# ADDENDUM NO. 1

COLTON H.S. – SDC CLASSROOM BUILDING

DSA No: 04-121991      File No: 36-H4      RCA Project No. 3-79-02

Sheet #: **ASK-1.1**

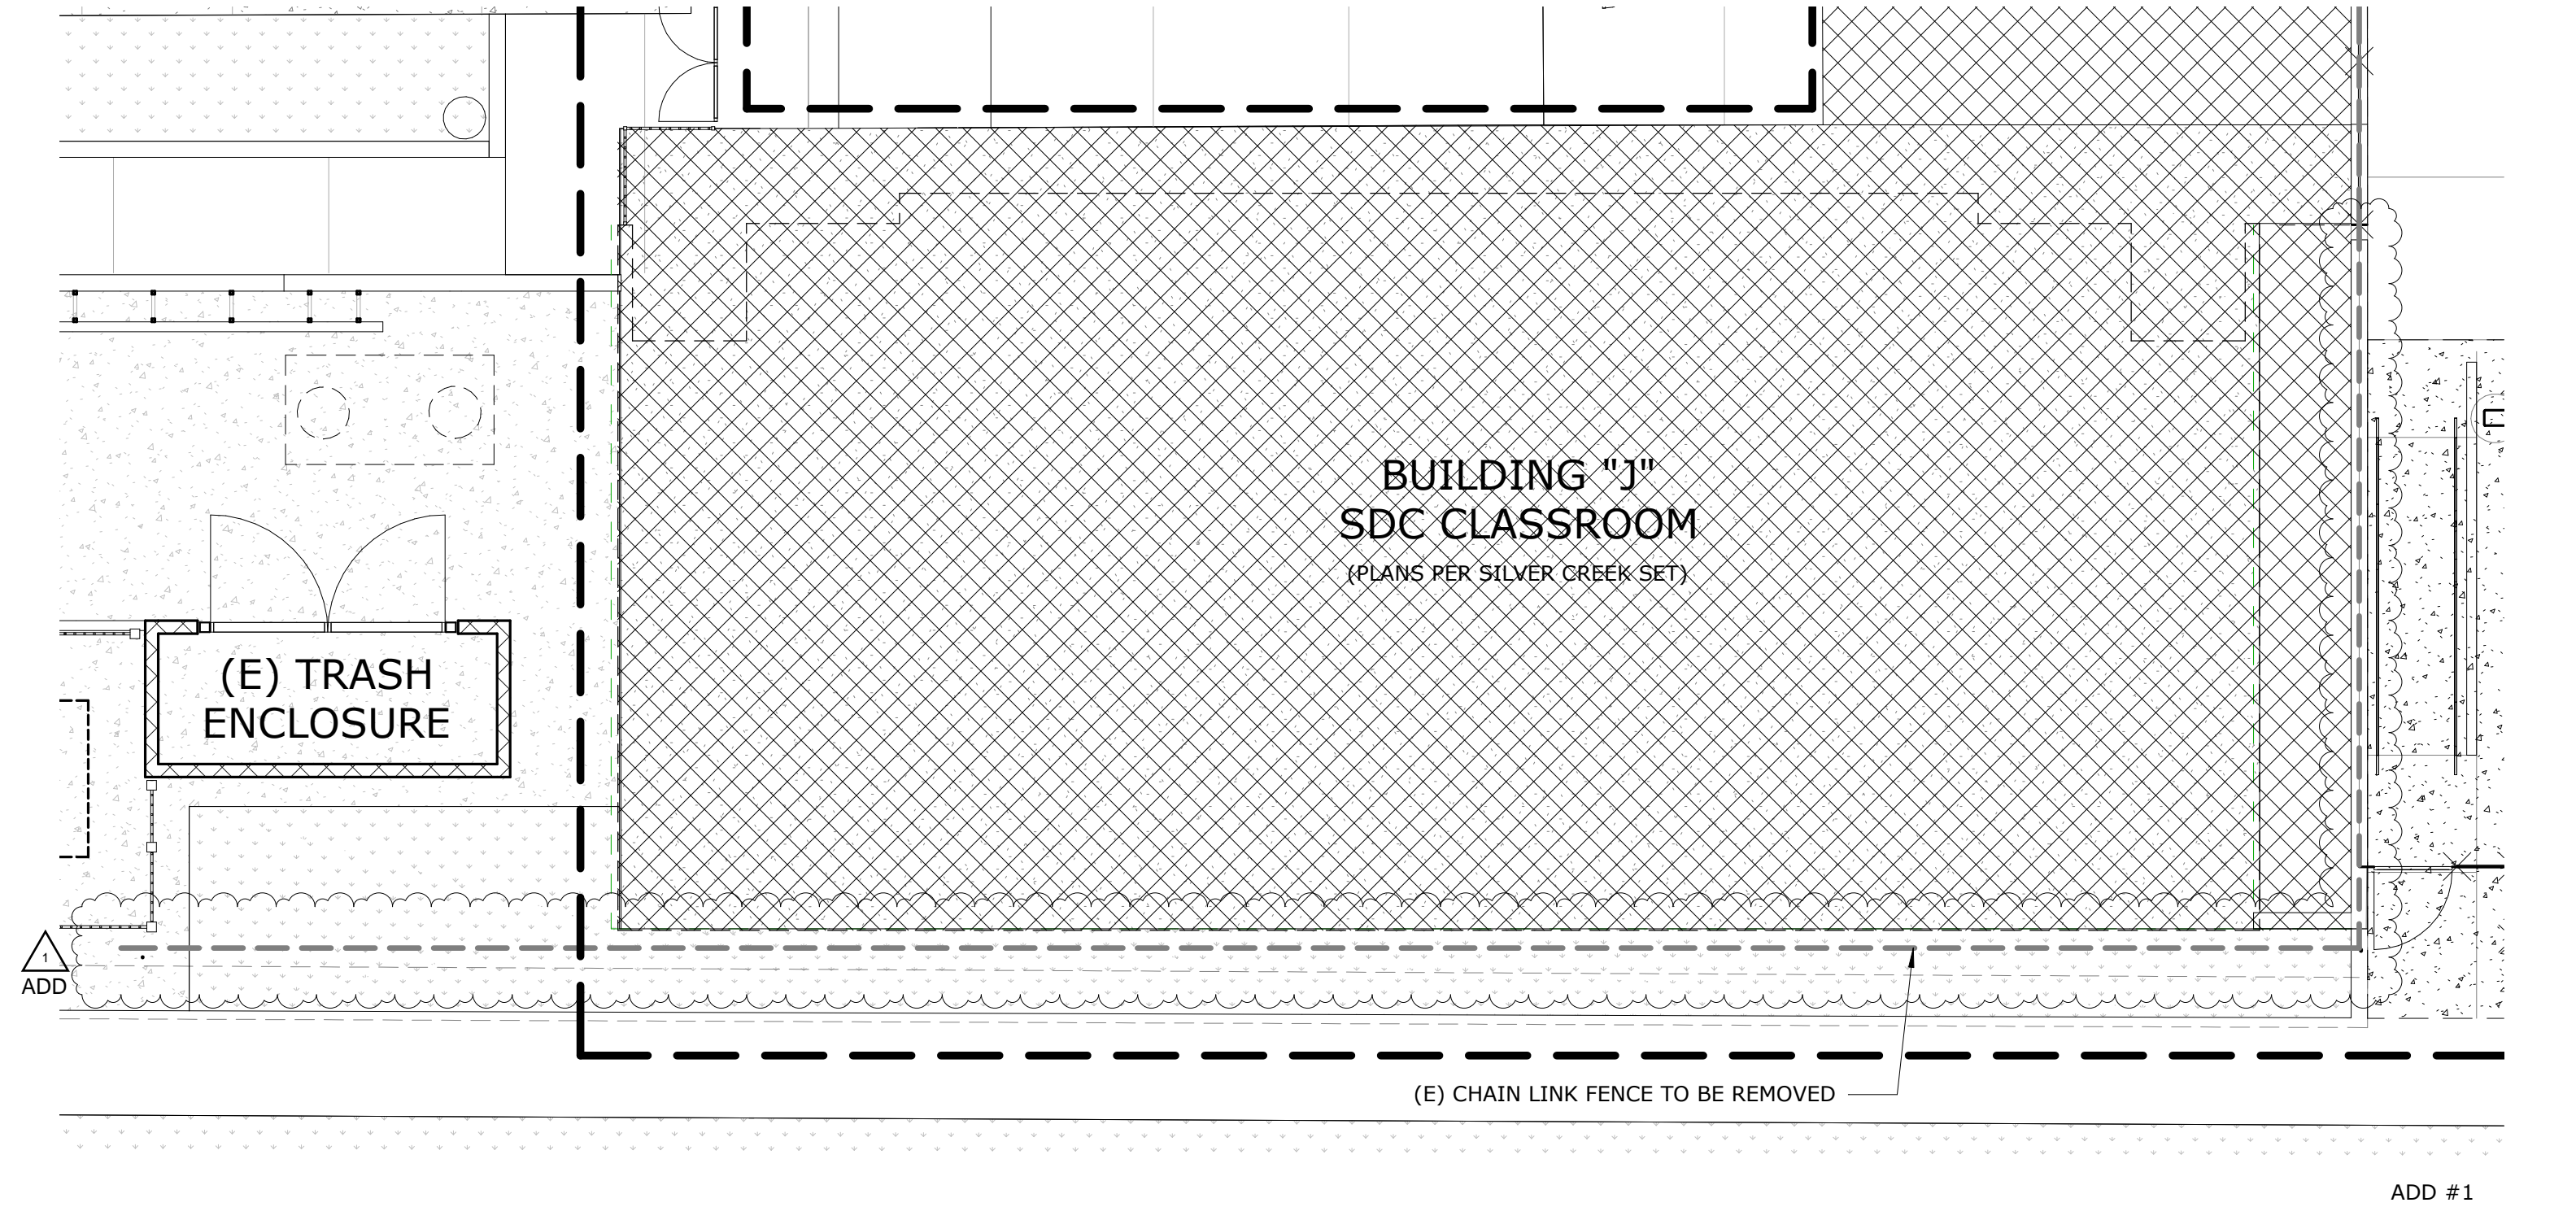
- Item No. 1.4      Reference Sheet AS-1.1 – OVERALL SITE PLAN & CODE ANALYSIS  
1.4.1      Revise per clouded areas of attached ASK-1.1:  
a.   Revise existing conditions
- Item No. 1.5      Reference Sheet AS-2.0 - DEMOLITION SITE PLAN.  
1.5.1      Revise per clouded areas of attached ASK-1.2:  
a.   Revise existing conditions  
b.   Revise removal of existing fencing
- Item No. 1.6      Reference Sheet AS-2.1 ENLARGED SITE PLAN  
1.6.1      Revise per clouded areas of attached ASK-1.3:  
a.   Revise existing conditions on site  
b.   Revise new fencing location

### C-3.1

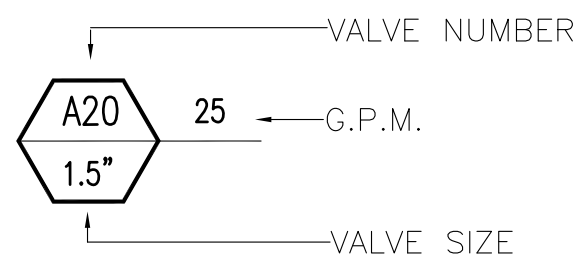
- Item No. 1.1      Reference Sheet C-3.1 - GRADING AND UTILITY PLAN  
1.1.1      Revise per clouded areas:  
a.   Relocate POC for Sewer, Storm Drain, and Water  
b.   Revise Inverse Elevations for drains  
c.   Revise spot elevations  
d.   Update Section "A-A"

1  
LI-1

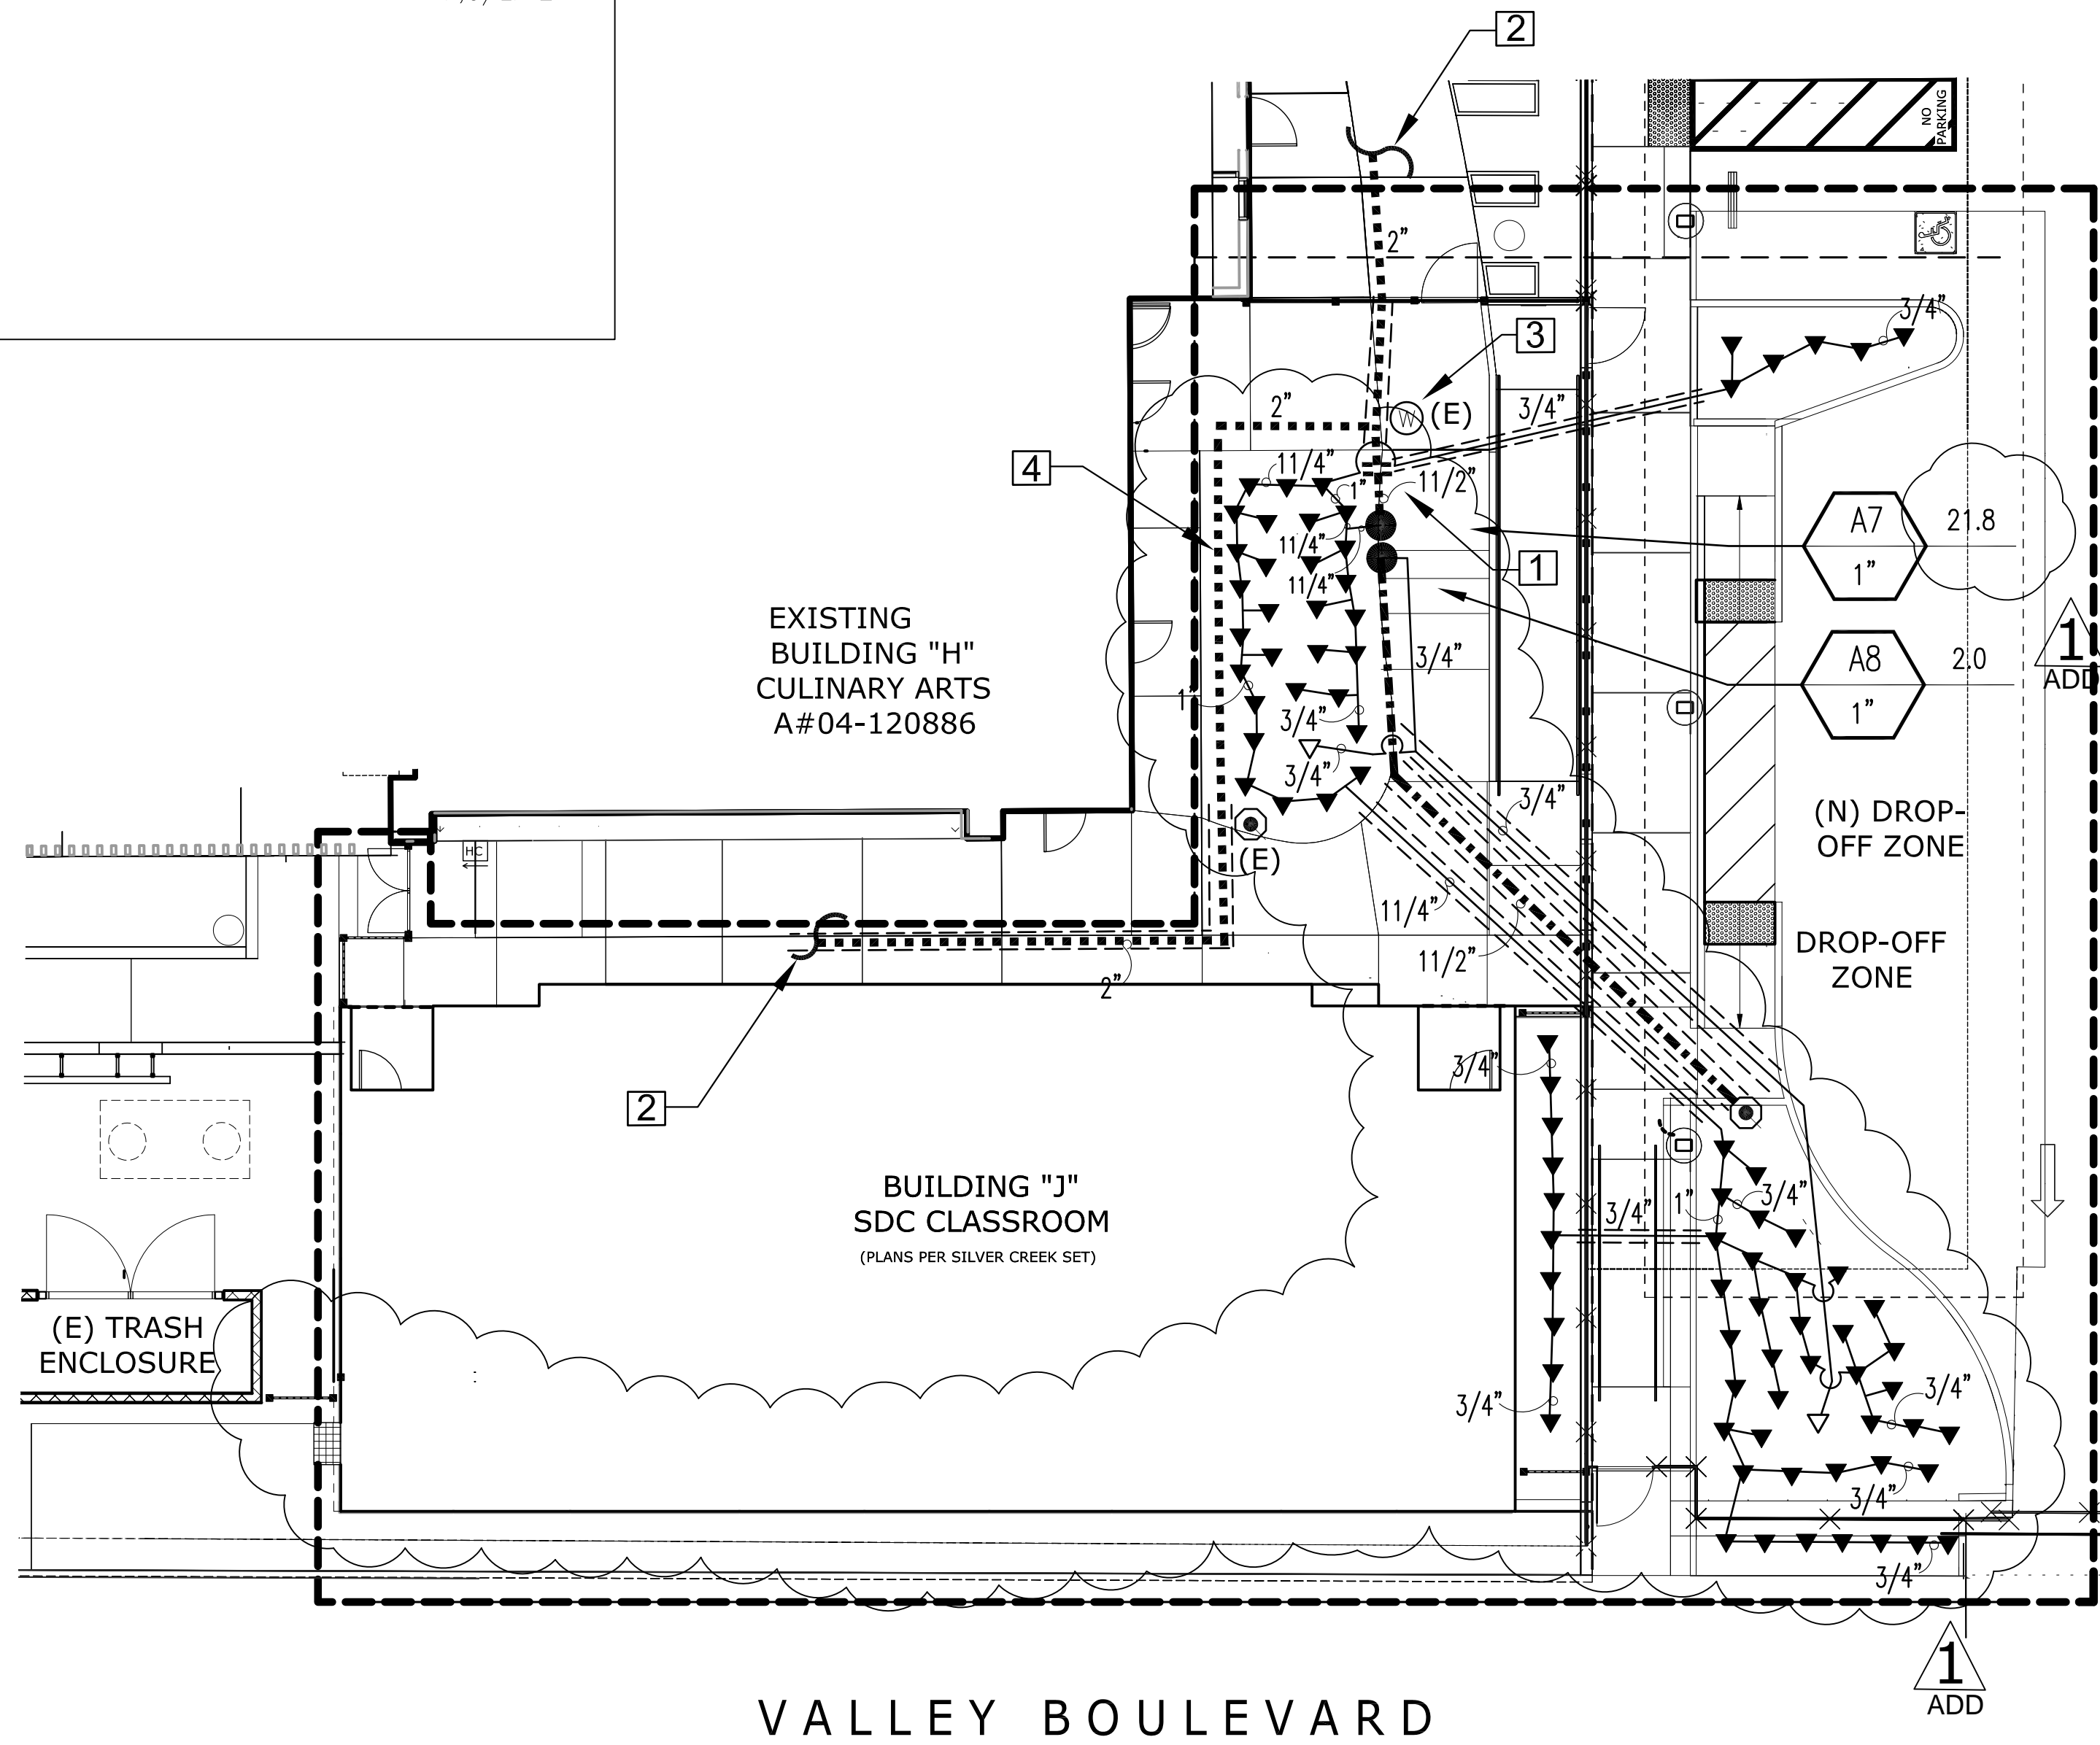
- Item No. 1.2      Reference Sheet LI-1 - IRRIGATION PLAN – LEGEND AND NOTES  
1.2.1      Revise per clouded areas:  
a)   Revise irrigation lines
- Item No. 1.3      Reference Sheet LP-1 - PLANTING PLAN AND LEGEND  
1.3.1      Revise per clouded areas:  
a.   Revise quantities of plants and planting areas
